M24C08-F package mechanical data modifications

This errata sheet applies to the M24C08-F, which is 8 Kbit serial I²C bus EEPROMs, and specifically to the devices delivered in 4-bump wafer-level chip-scale packages (WLCSP).

Figure 2. D and E front side view

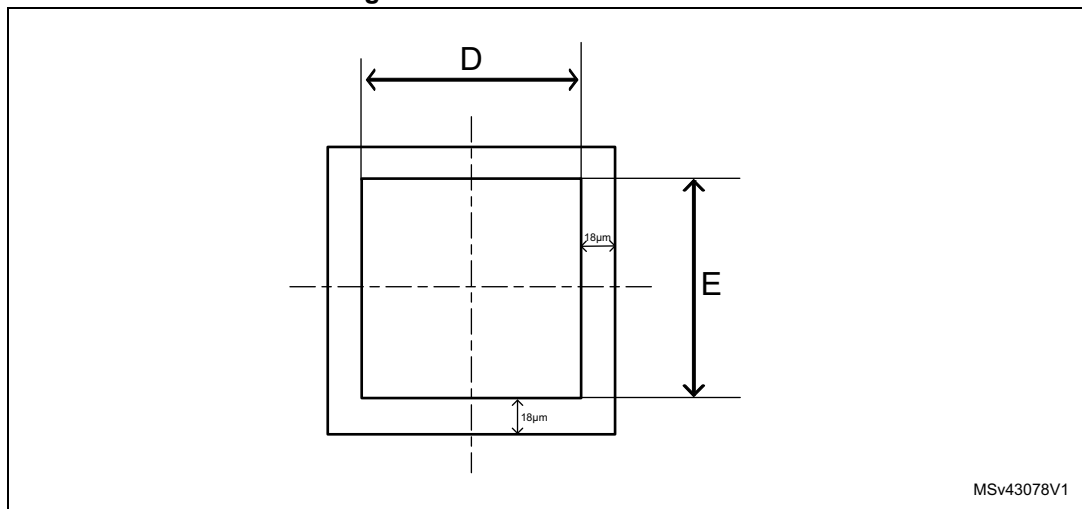
- The D and E values on M24C08-F datasheet corresponding to front side view (ball side) as shown in [Table 2](#), instead of back side view (marking side view) as shown in [Table 3](#).

Symbol	Millimeters			Inches		
	Min	Typ	Max	Min	Typ	Max
D	-	0.685	0.705	-	0.0270	0.0278
E	-	0.695	0.715	-	0.0274	0.0281

Figure 3. D and E back side view

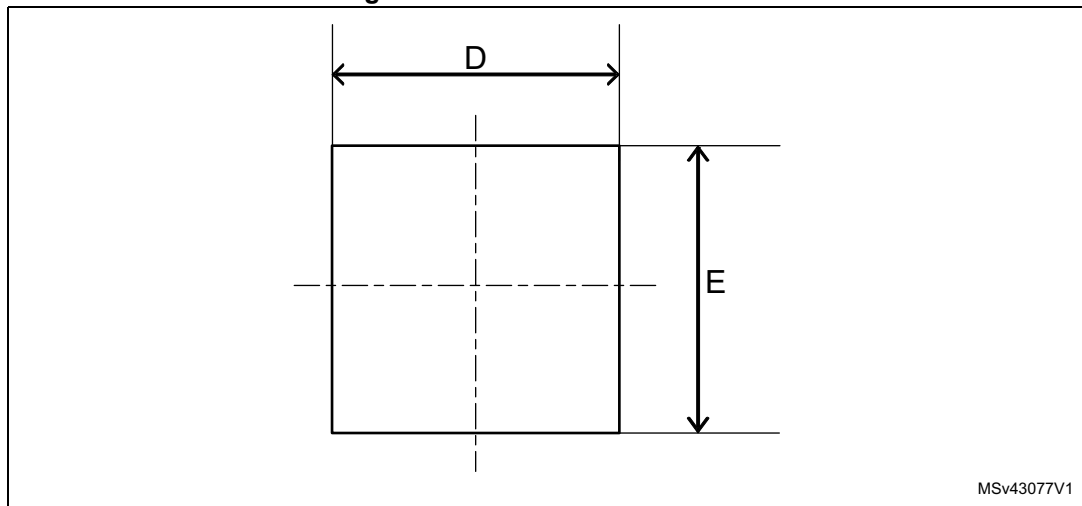
This document refers to the changes of dimensions D and E (see [Figure 3](#)) described in the M24C08-F datasheet, in tables detailing the dimensions of the Thin WLCSP 4-bump package.

D and E values must be modified to correct the following mistake:

Symbol	Millimeters			Inches		
	Min	Typ	Max	Min	Typ	Max
D	-	0.703	0.723	-	0.0277	0.0285
E	-	0.713	0.733	-	0.0281	0.0289

Figure 4. D or E side view

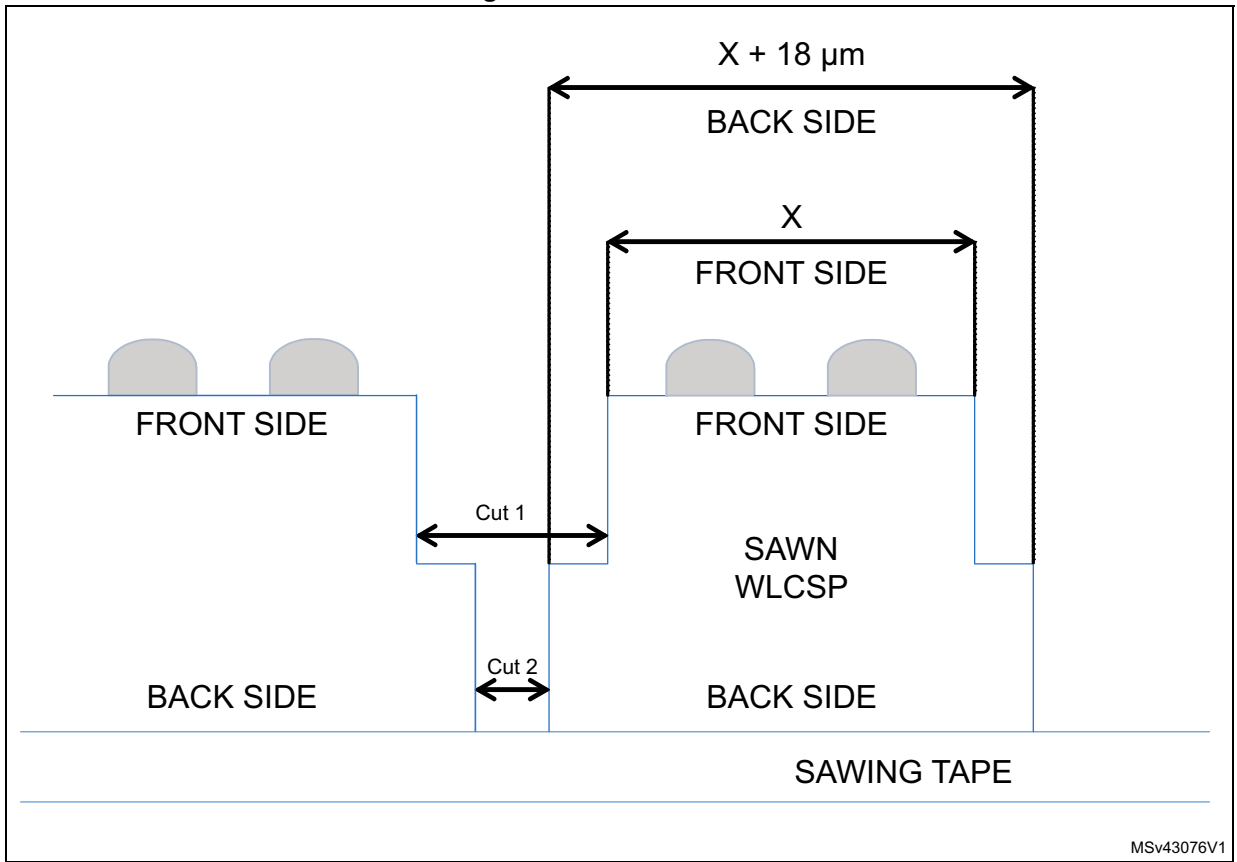
The difference between back side and front side dimension is 18 μm (0.018 mm). This difference is due to two-step sawing process, where cut 1 and cut 2 are performed with blades having different thickness (see [Figure 4](#) in which X represents D or E and it has the same value and tolerance).
